ADDENDUM NO. 1

TOWN OF RIVER BEND
WASTEWATER TREATMENT PLANT ENHANCEMENTS
DWI PROJECT NO. SRP-W-ARP-0241
DRAWING NO. W-3575-A

ADDENDUM NO. 2

**TOWN OF RIVER BEND
WASTEWATER TREATMENT PLANT ENHANCEMENTS
DWI PROJECT NO. SRP-W-ARP-0241
DRAWING NO. W-3575-A**

DESIGNED BY:	GJC	PROJECT No.	2022129	SHEET No.	C1-A
DRAWN BY:	IM/EDN	DRAWING No.	W-3575-A		
CHECKED BY:	GJC	SCALE	AS NOTED		
		DATE	12/5/2023

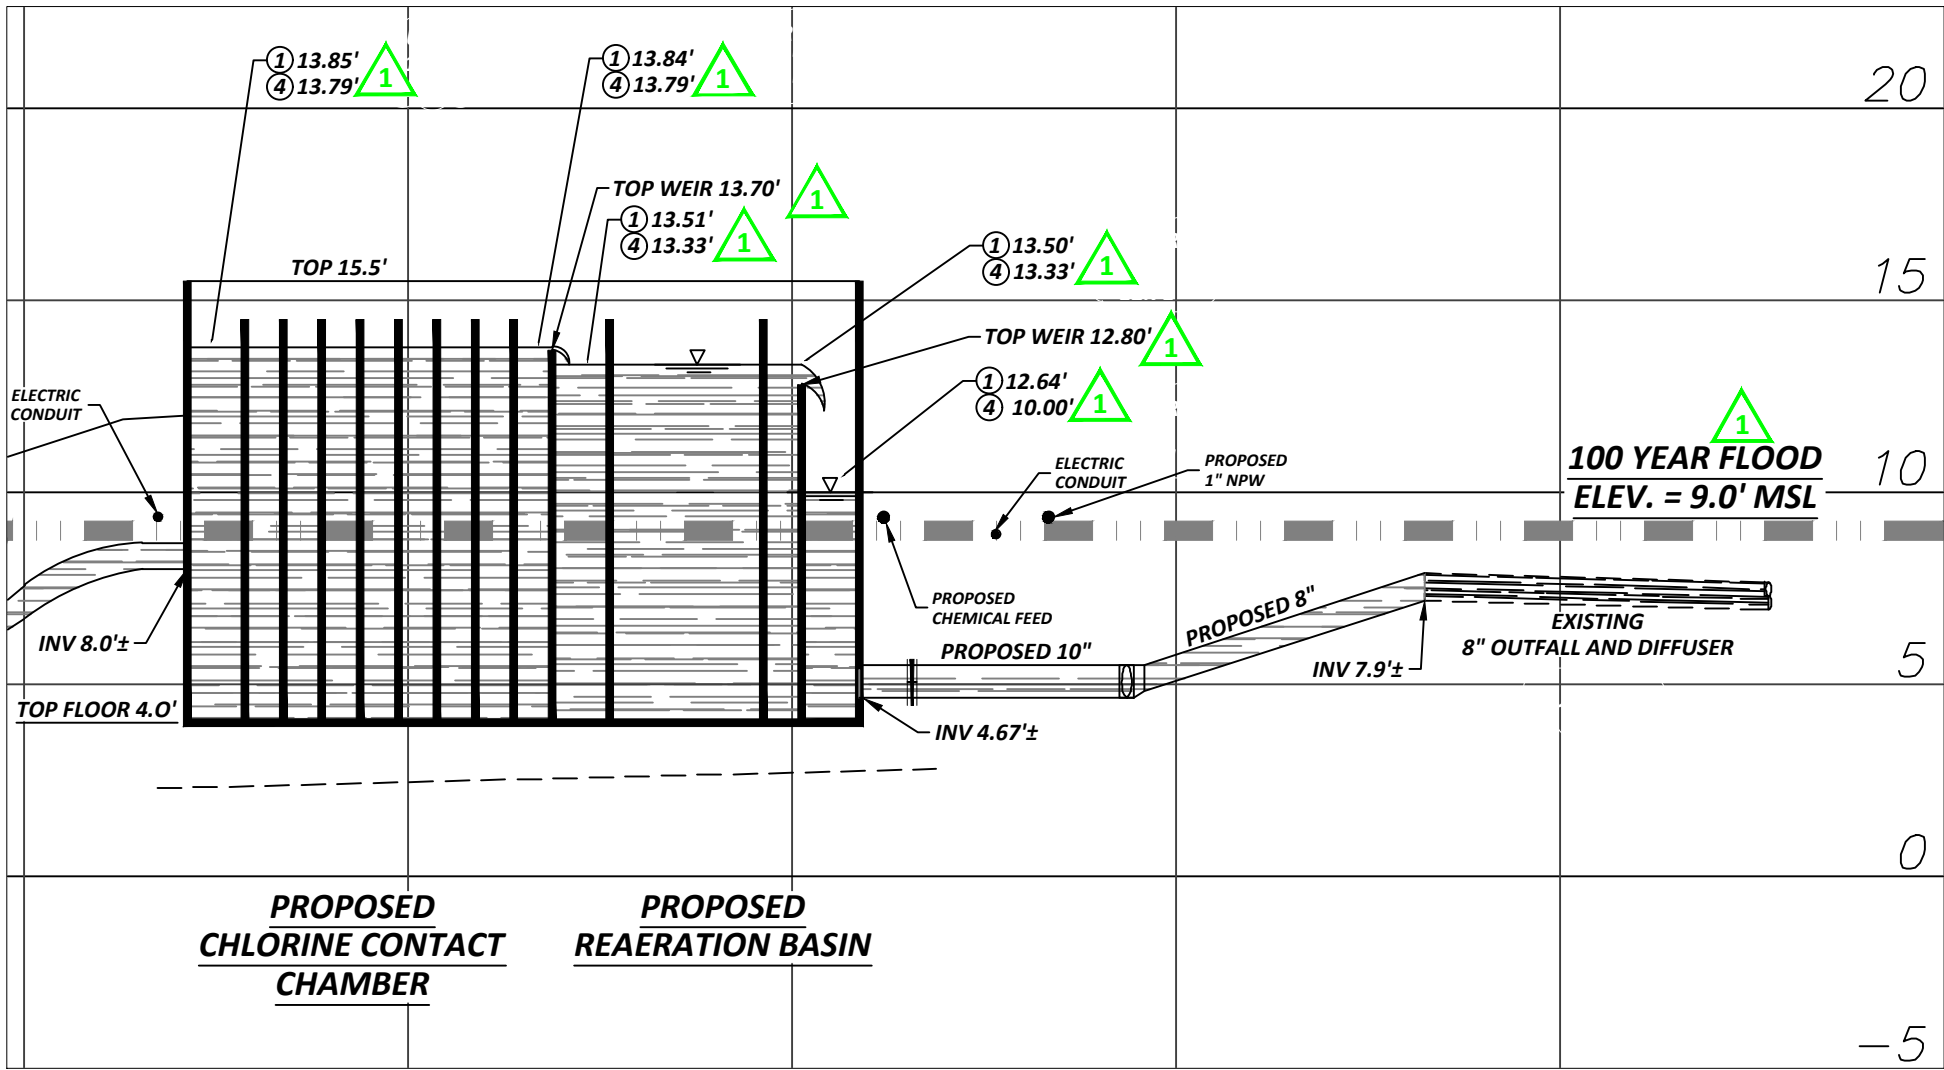
2. SHEET C1 – HYDRAULIC PROFILE

Revise the 100-year flood elevation note as follows:

Attached with this Addendum are two (2) 8.5”x11” drawings of the revisions to Sheet C1 including the 100-year flood elevation outlined above. Revisions are also included to affected weir invert and water surface elevations for the proposed reaeration basin, chlorine contact chamber, and tertiary filter clearwell due to the revised 100-year flood. See page AD2-9 through AD2-10 attached. Full size revised plan sheets will be incorporated into the drawings released for construction.

CHLORINE CONTACT - PLAN AND SECTION

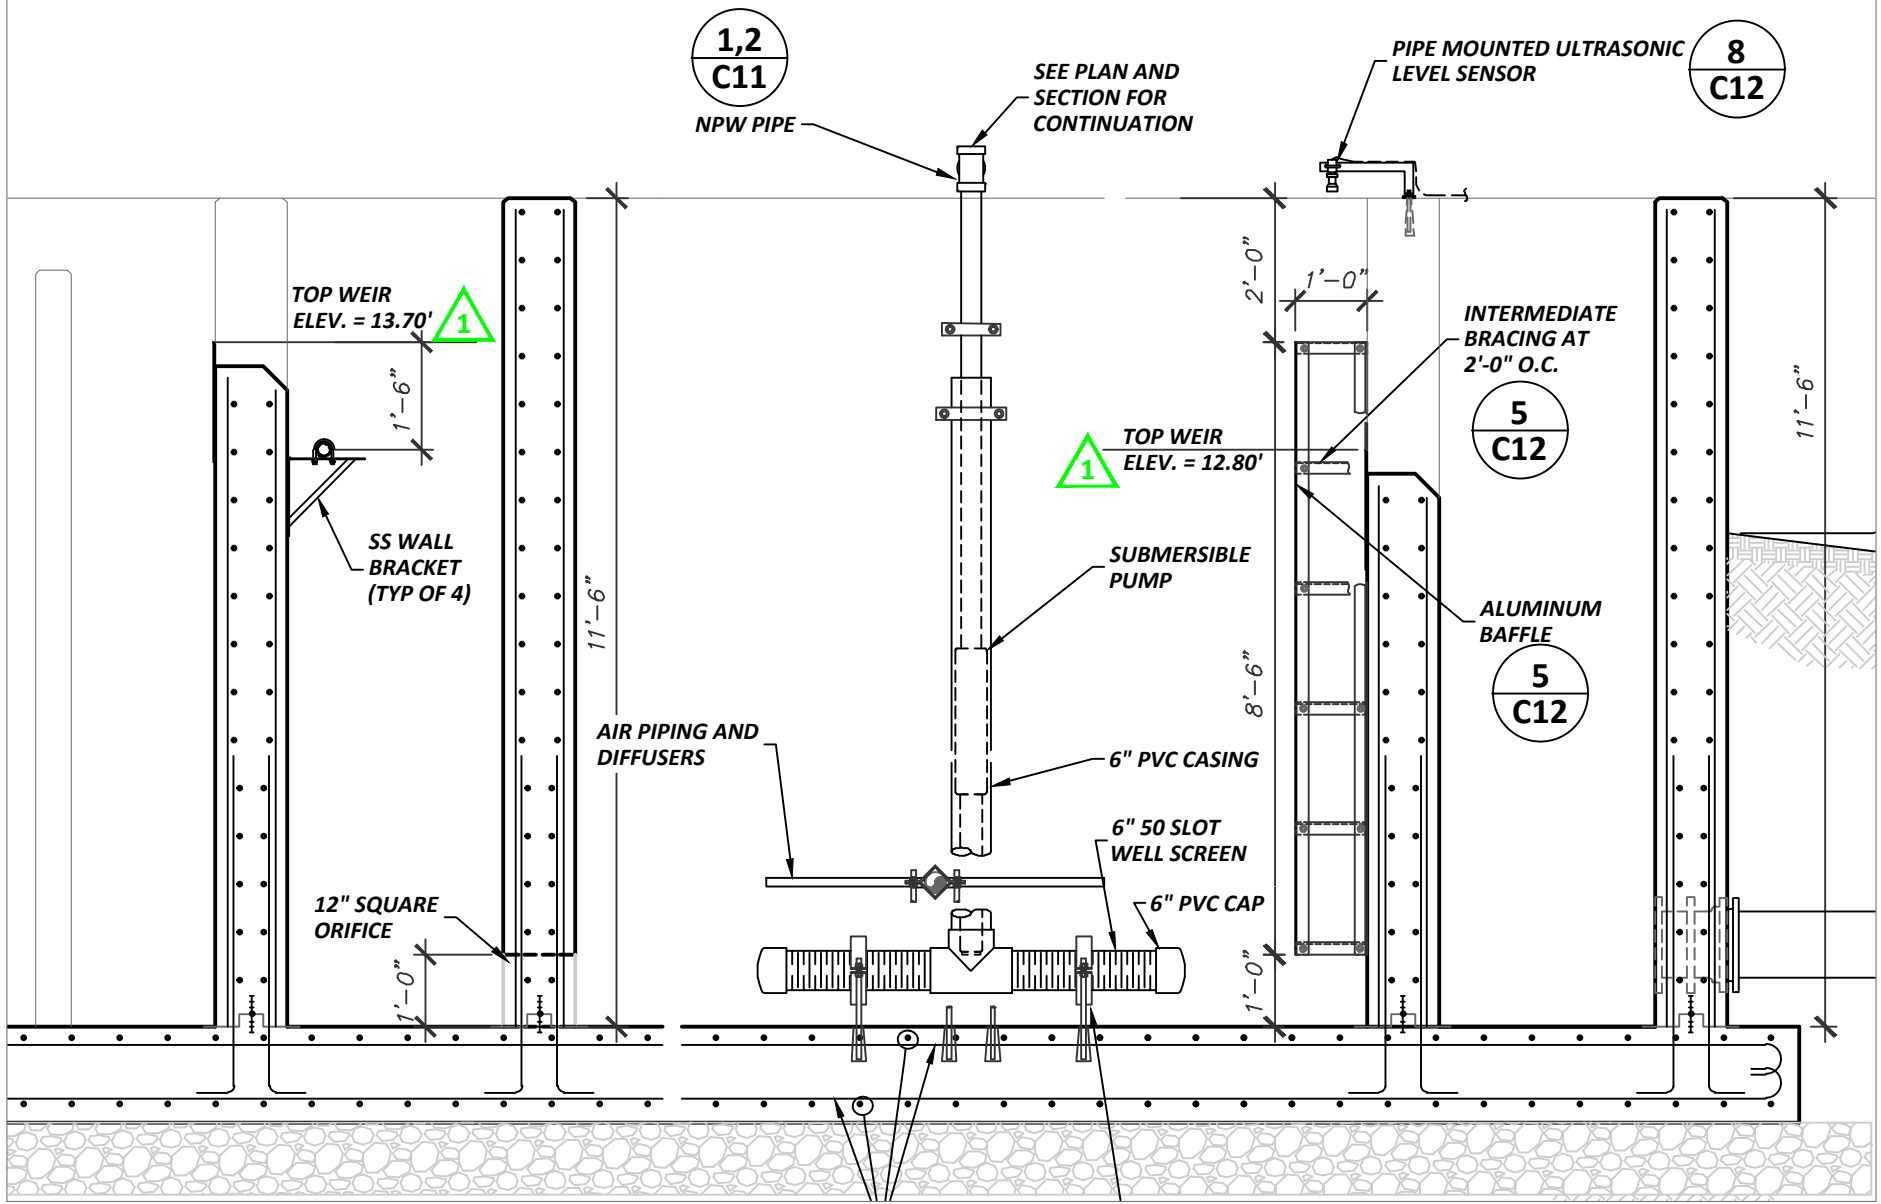
3. SHEET C11 – CHLORINE CONTACT – PLAN AND SECTION

Revise the weir elevations for the proposed chlorine contact chamber as shown on the attached 8.5”x11” drawing. See page AD2-11 attached. Full size revised plan sheets will be incorporated into the drawings released for construction.

① FIXED WEIR SCHEDULE

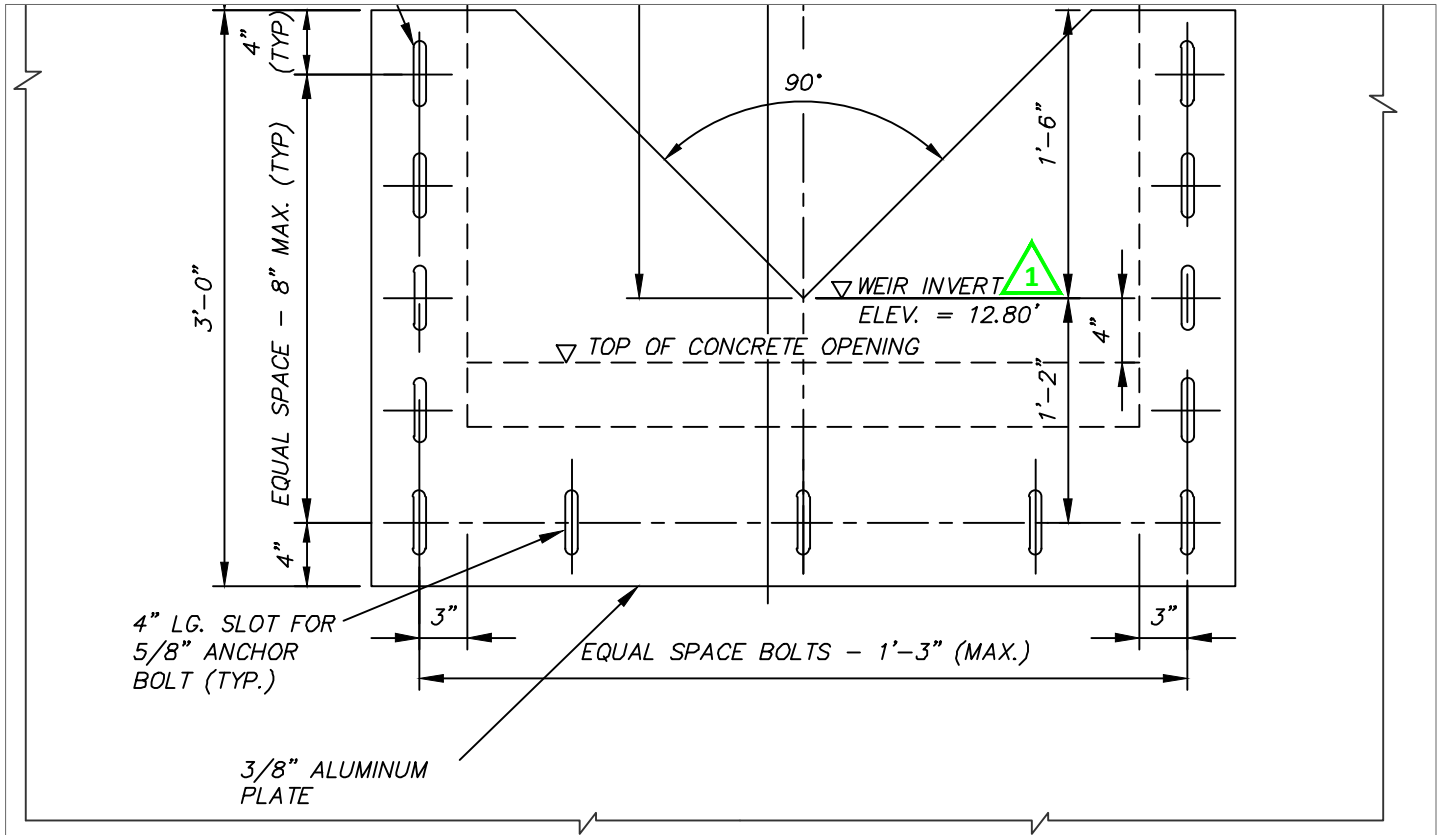
4. SHEET C12 – CHLORINE CONTACT DETAILS

Revise Detail 1 - FIXED WEIR SCHEDULE and Detail 3 – FIXED V-NOTCH WEIR – DETAIL as shown on the attached 8.5”x11” drawing. See page AD2-12 attached. Full size revised plan sheets will be incorporated into the drawings released for construction.

**AEROBIC DIGESTER -
PRESTRESSED CONCRETE -
ALTERNATE BID**

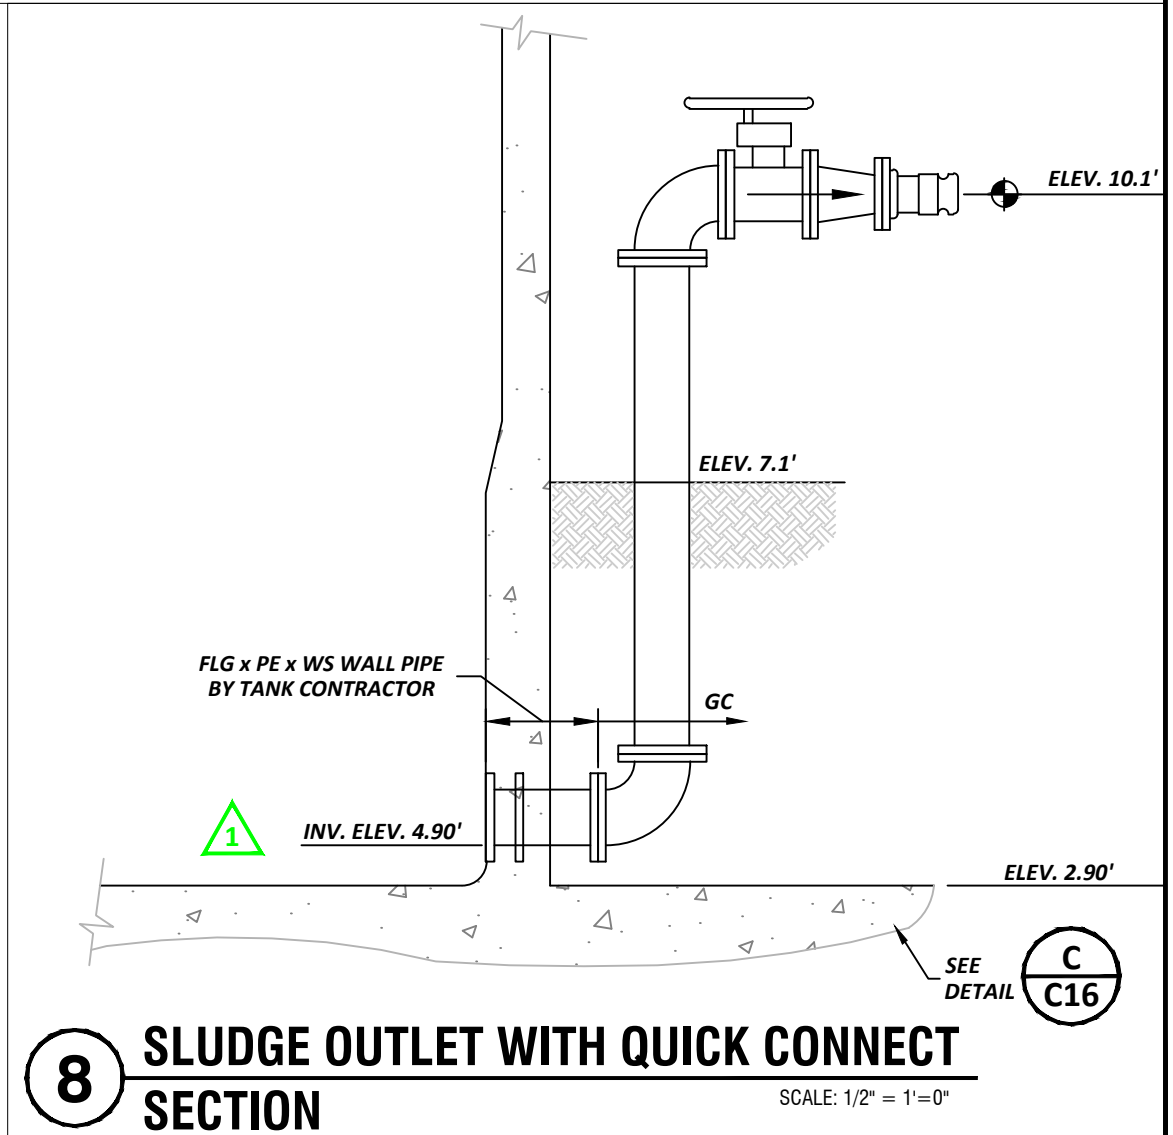
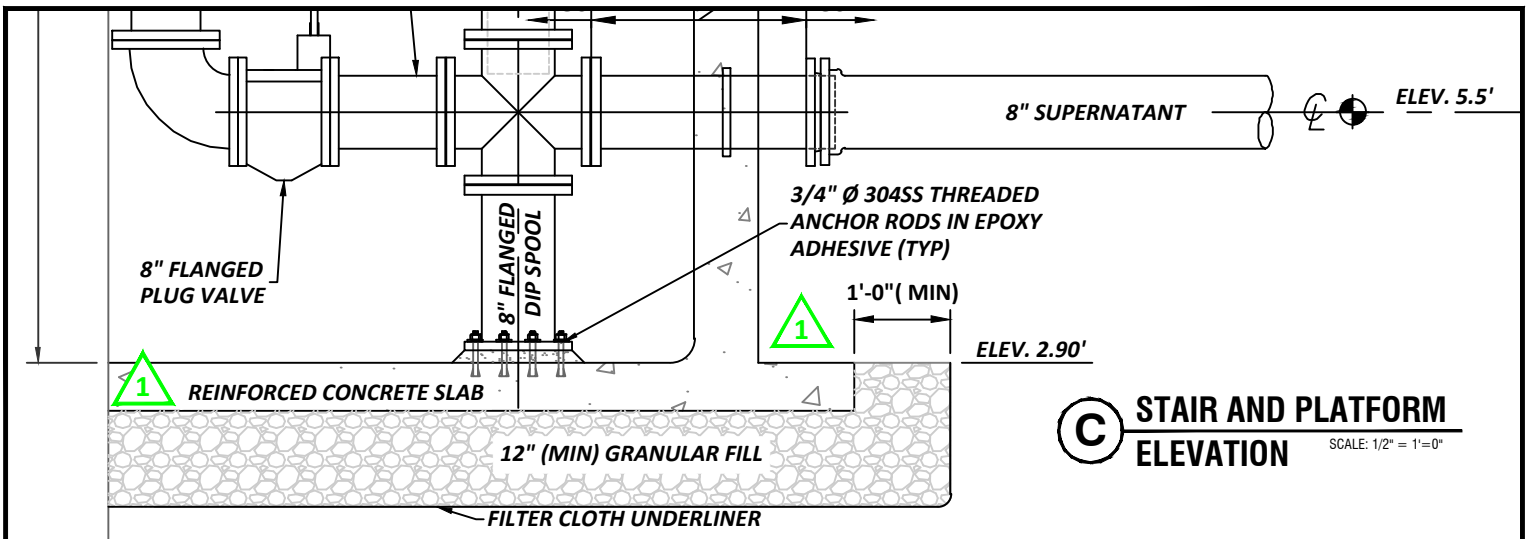
5. SHEET C16 – AEROBIC DIGESTER – PRESTRESSED CONCRETE – ALTERNATE BID

On Section 8 – SLUDGE OUTLET WITH QUICK CONNECT, add an invert elevation of 4.90’ to the sludge outlet wall pipe.

On Detail C – STAIR AND PLATFORM ELEVATION, delete the “4’-0” (MIN)” extended base note. Also revise “~~12” (MIN)~~ REINFORCED CONCRETE SLAB” note.

Attached with this Addendum is an 8.5”x11” drawing of the revisions to Sheet C16 for Section 8 and Detail C as outlined above. See page AD2-13 attached. Full size revised plan sheets will be incorporated into drawings released for construction.

VAULT DETAILS			
WWTP 2022 ENHANCEMENTS TOWN OF RIVER BEND CRAVEN COUNTY - NORTH CAROLINA			
DESIGNED BY:	GJC	PROJECT No.	2022129
DRAWN BY:	IM/EDN	DRAWING No.	W-3575-A
CHECKED BY:	GJC	SCALE	AS NOTED
		DATE	12/5/2023
			D1

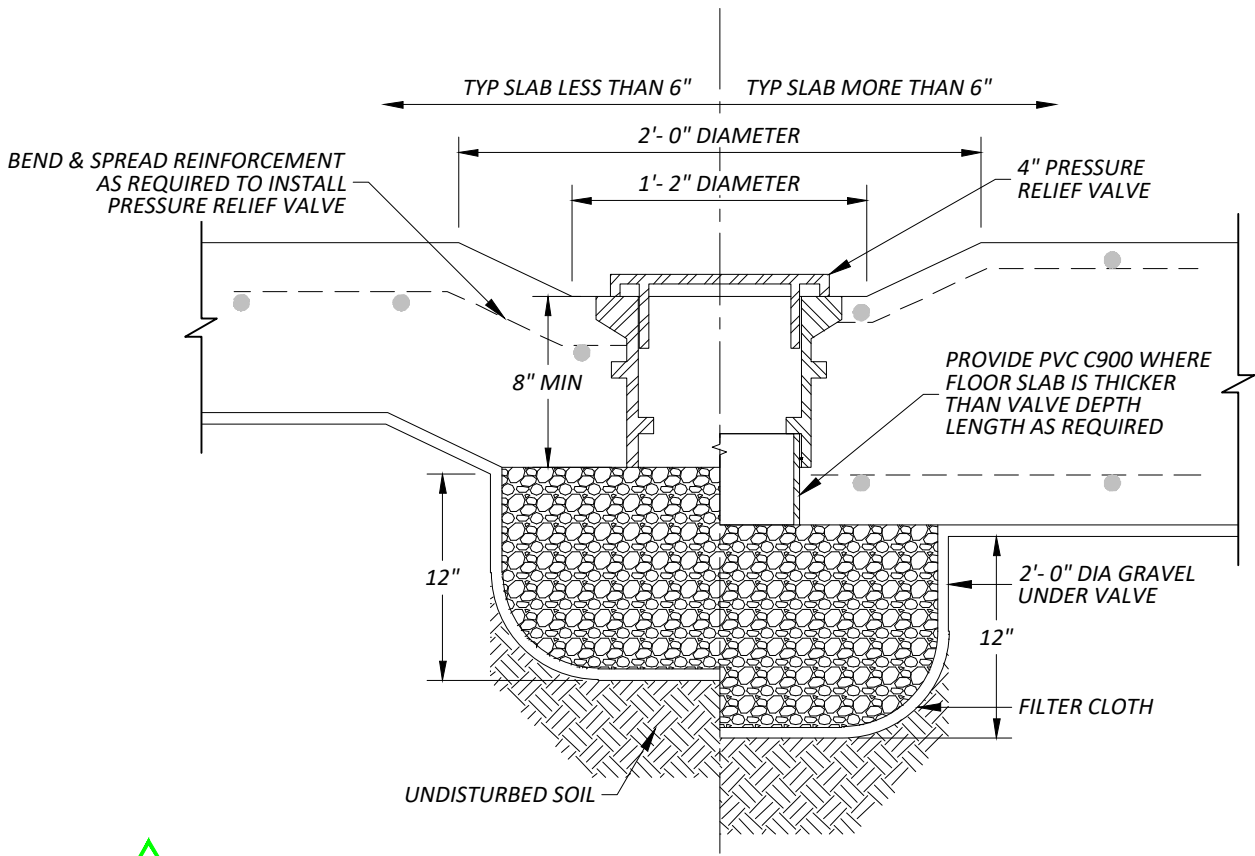
6. SHEET D1- VAULT DETAILS

Add a detail No.11 to Sheet D1 entitled “PRESSURE RELIEF VALVE WITH EXTENSION”

Attached with this Addendum is an 8.5”x11” drawing of the revisions to Sheet D1 as outlined above. See page AD2-14 attached. Full size revised plan sheets will be incorporated into the drawings released for construction.
